your reference: EN010130 our reference: PE-00169-23

Ref. Application: EN010130

Development consent to construct, operate and maintain, and decommission the Project, which is located approximately 54km from the Lincolnshire coastline pursuant to section 14(1)(a) and 15(3) of the Planning Act 2008.

Figure 1.1 : Extract from Environmental Statement Onshore Order Limits Plan – Figure 3.3

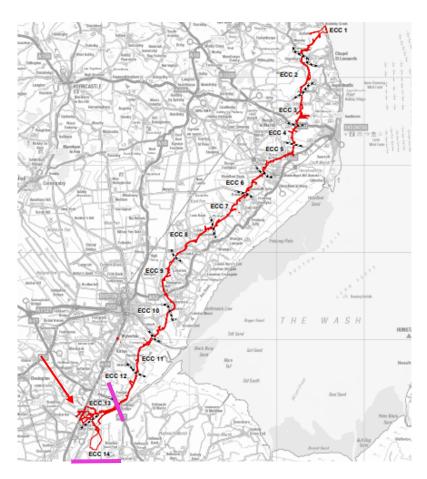
Within South Holland District Council, segments ECC13 and ECC14 of the onshore works (figure 1.1) are relevant to the assessment. The proposed works in these areas includes underground cables along with the onshore substation area, which forms the largest element of the onshore works for the lifetime of the development.
